**CITY OF MANZANITA PLANNING COMMISSION
FINDINGS OF FACT AND CONCLUSIONS**

Design review of a mixed use (residential and commercial) building in the Commercial zone

Location: 253 Laneda Avenue
Assessor's Map: Map 3N-10-29BD, Tax Lot 16900
(Lot 15, Block 13, Manzanita Beach)
Applicant: By the Sea Investments IV, LP
Owner: Same as applicant
Zoning: C-1 (Commercial)
Criteria: This application will be evaluated against the design review standards listed in Sections 4.070, 4.080, 4.090 and 4.137 through 4.158 of Ordinance 95-4, and the standards for the Commercial (C-1) zone listed in Section 3.040 of Ordinance 95-4.

Date of Hearing: February 17, 2015

SITE PLAN

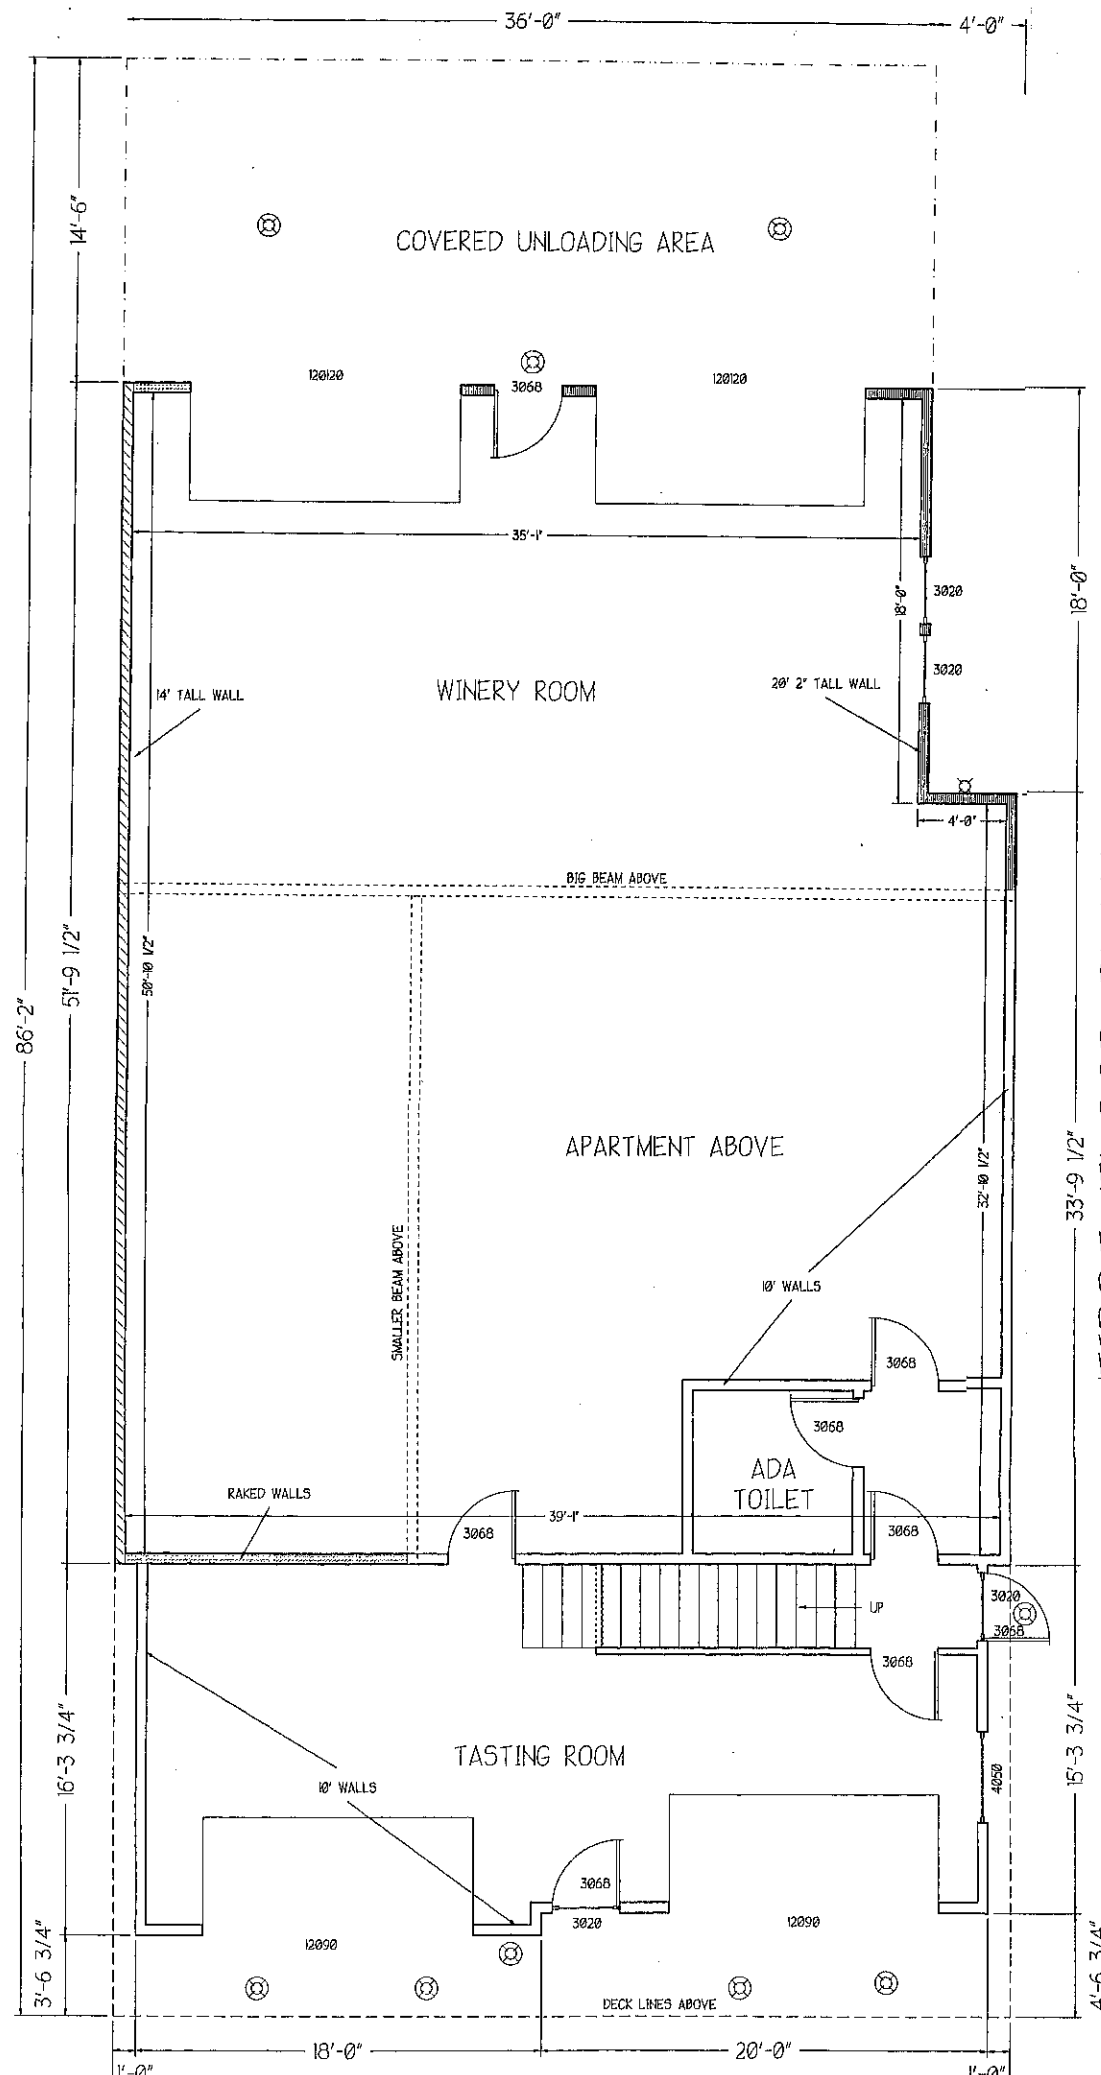
Findings: The minimum front, side, and rear yard setbacks are met. Architectural features may extend into any required setback by no more than 18 inches (Ord. 95-4, Section 6.040); the plan shows the cover over the east entrance door as being 36 inches into the required 5 foot setback and should be modified. The cover over the rear loading area extends 12 inches into the required 5 foot setback and is acceptable.

Findings: A total of 20% of the lot area is required to be in landscaping. The commercial development is exempt from on-site parking requirements under Section 4.090(2). For the 5,000 square foot lot, the requirement would be for 1000 square feet of landscaping. **About 1,230 square feet of landscaping is shown on the site plan revised after the hearing.** This standard is met.

Findings: The proposed general landscape plans use plants that are common to this area. The applicant must specify how the landscaping will be maintained **and kept to the size shown on the drawing** . Otherwise, this criterion is met.

Findings: A total of 20% of the lot area is required to be in landscaping. For the 5,000 square foot lot, the requirement would be for 1,000 square feet of landscaping. Of this amount, 500 square feet of landscaping (50%) must be in living plant material. **This minimum amount must be in the front and side yards. About 1,230 square feet of landscaping is shown in the front and side yards of which 500 square feet of landscaping is in living plant material (after revisions made at the hearing)** . There is a total of about **1,230 square feet of landscaping shown on the site plan.** This standard is met.

Findings: The commercial space is exempt from on-site parking requirements per Section 4.090(2). The apartment on the second floor requires one parking space. The Applicant shows 2 parking spaces on the plan, including the accessible space required by the Americans with Disabilities Act (ADA). As only two parking spaces are designated, the requirement for maneuvering room specified in Section 4.080(10) does not apply. A parking space is defined in Section 1.030 of Ordinance 95-4 as a space 9 feet by 18 feet. All of the spaces on the plan meet this standard. The Applicant plans to provide a mutual easement between the subject property and the adjacent property to the east so that users of both properties may use the ADA accessible space. As the ADA accessible space is intended to be placed partially on both lots, the mutual easement is required.

1. At least 60 additional square feet of living plant landscaping in the front and side yards shall be shown on the final site plan to meet the requirement for 50% of the required landscaping to be in living plant materials.

2. Applicant shall submit a plan to demonstrate how the living material landscaping will be maintained and kept to the size shown on the design plan.
3. Applicant shall submit for City review and approval a mutual easement which allows the ADA accessible parking space to be used by both properties currently owned by the Applicant. The applicant will also provide a driveway easement across Lot 14 to Lot 15. Proof of filing such easements shall be a condition of issuing any building permit on Lot 15 (subject lot).

5. The cover shown over the east entrance shall be modified to conform to the standards for architectural features extending into required yards.

OUTDOOR LIGHTING

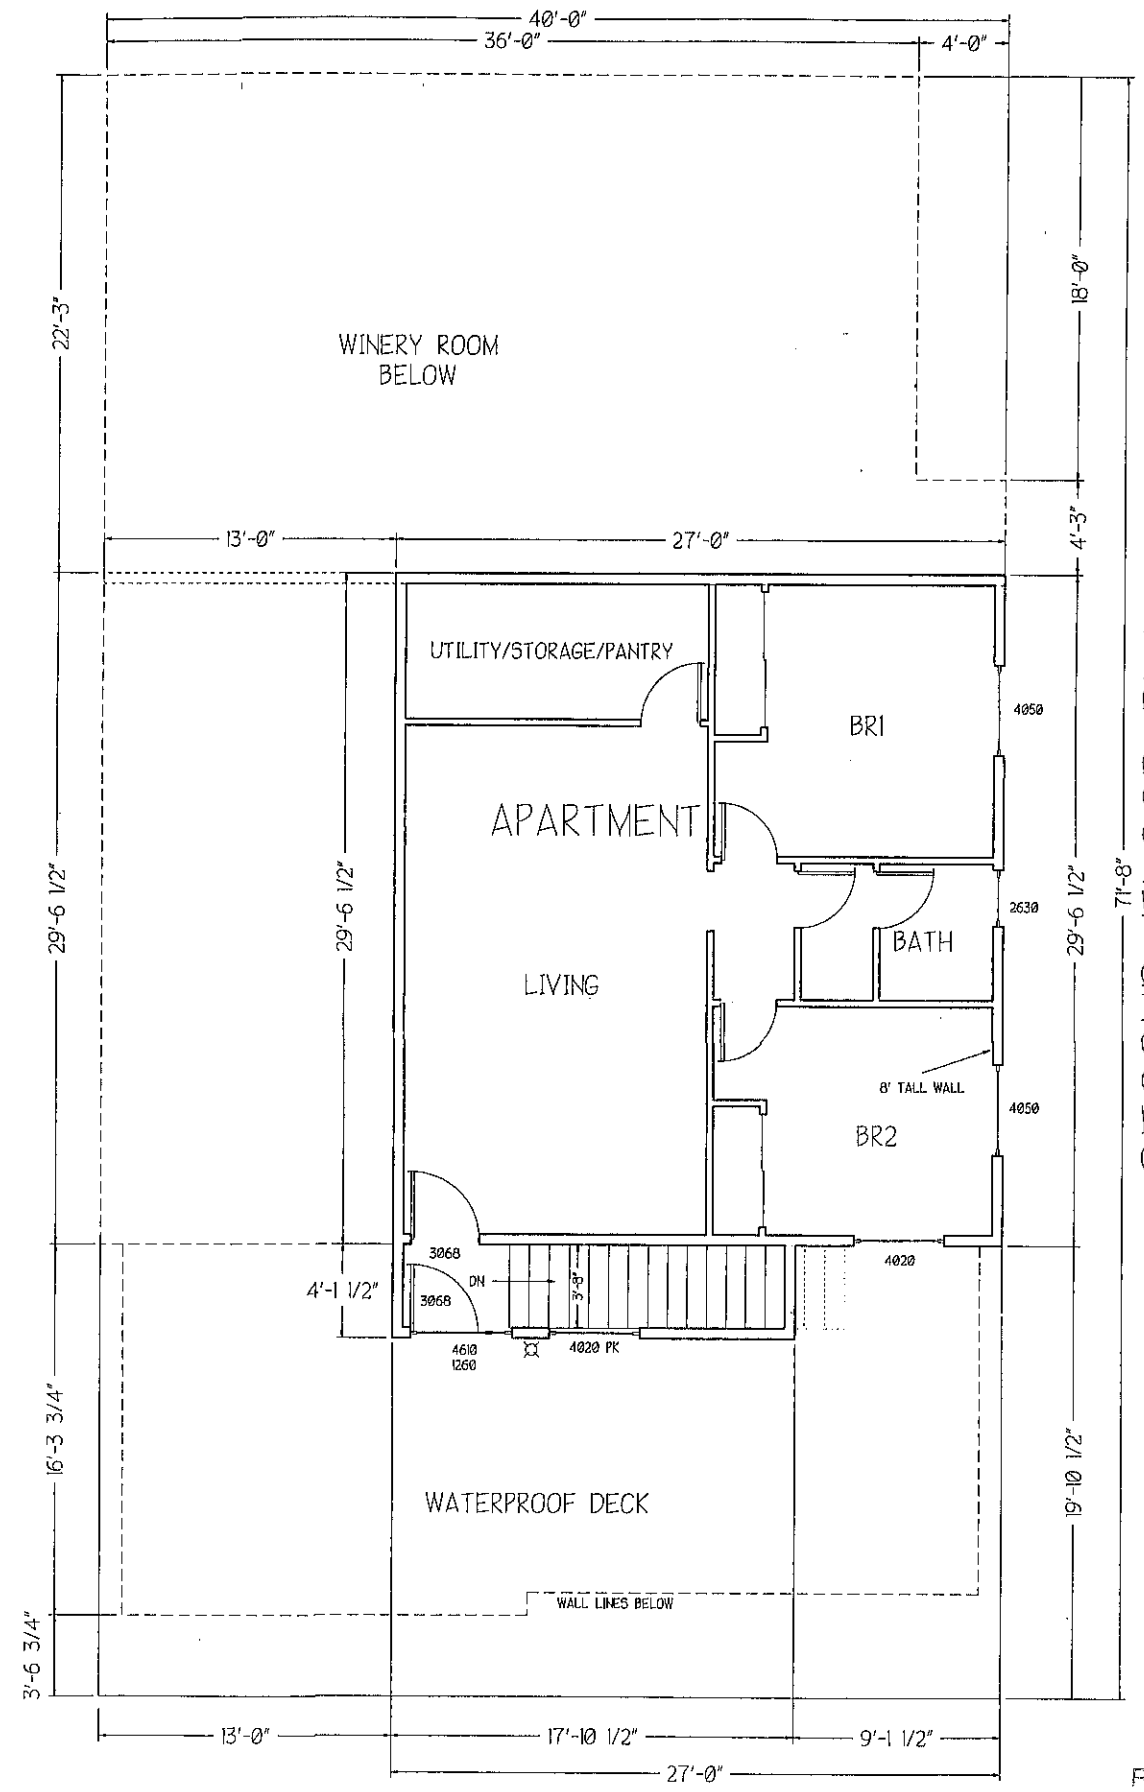
Findings: The lighting identified on the plan is appropriate in intensity and location. There does not appear to be any conflicts with neighboring uses given that the proposed lighting is screened and directed downward. Pictures of the proposed fixtures were provided. This criterion is met.

ELEVATIONS.
EXTERIOR MATERIALS:
 1ST LEVEL: -----Cedar Board and Batten.
 UPPER LEVEL:-Cedar Shingles
 WINDOWS:-----"Milgard" Vinyl w/ 1"x 4" Exterior Painted Trim.
 GUTTERS:----- 5" Grey Aluminum.
 ROOF: ----- Architectural Grade Asphalt Composition Roofing; Color to be "Driftwood".

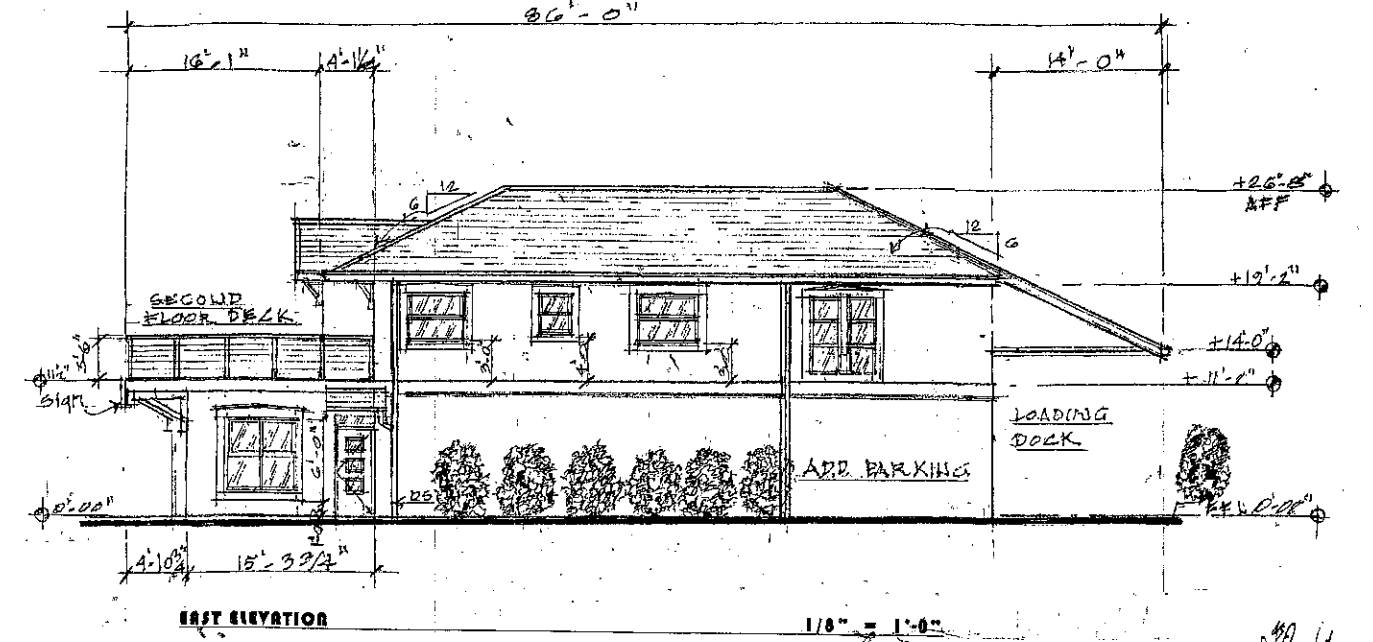
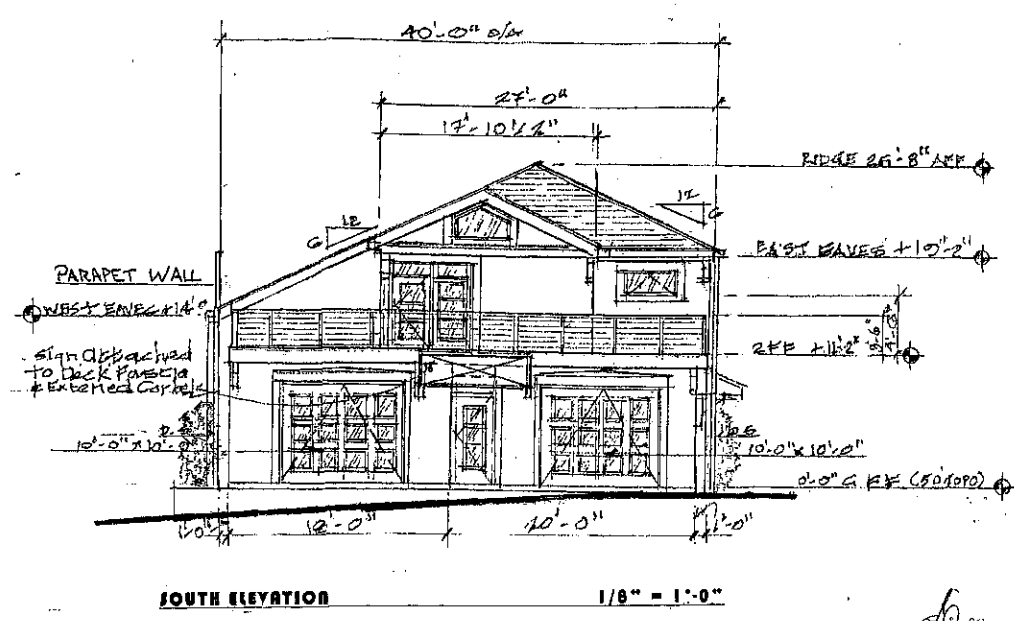
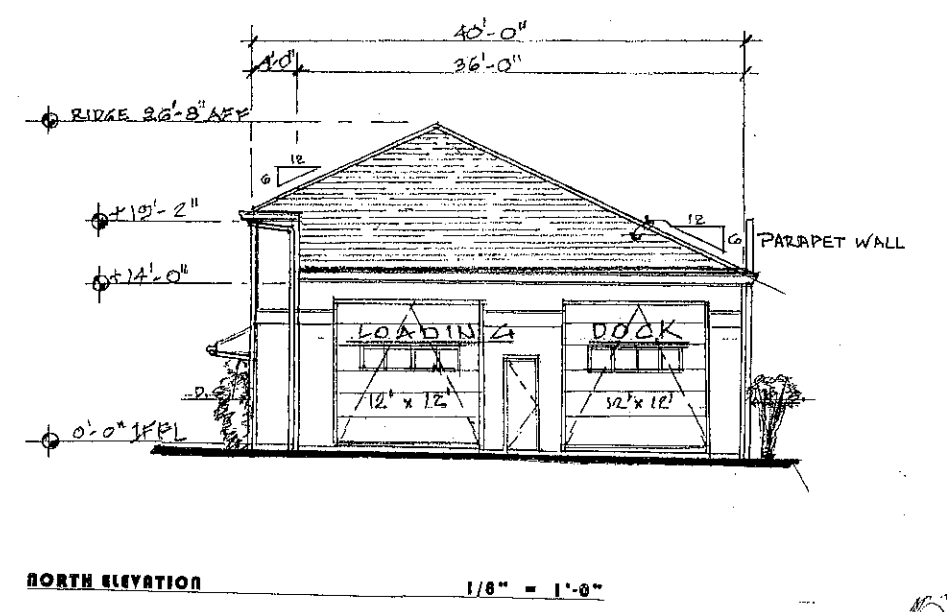
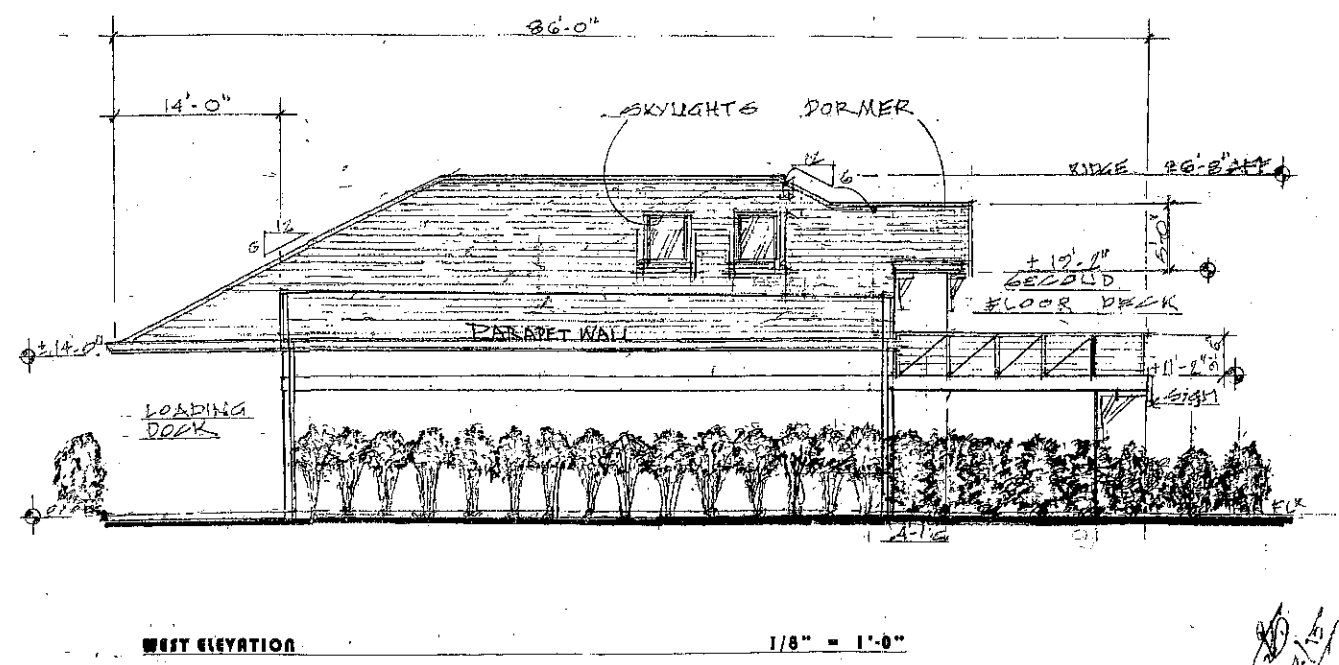
Findings: The building is shown to be 26 feet, 8 inches in height and within the 28 feet, 6 inches maximum building height.

Findings: The design uses a recessed second floor and deck as well as various wall and window treatments to create visual interest. The roll up garage doors on the front of the building are acceptable **as the dark brown trim on the doors blends in with the primarily wood siding as described by the Applicant during the hearing.**
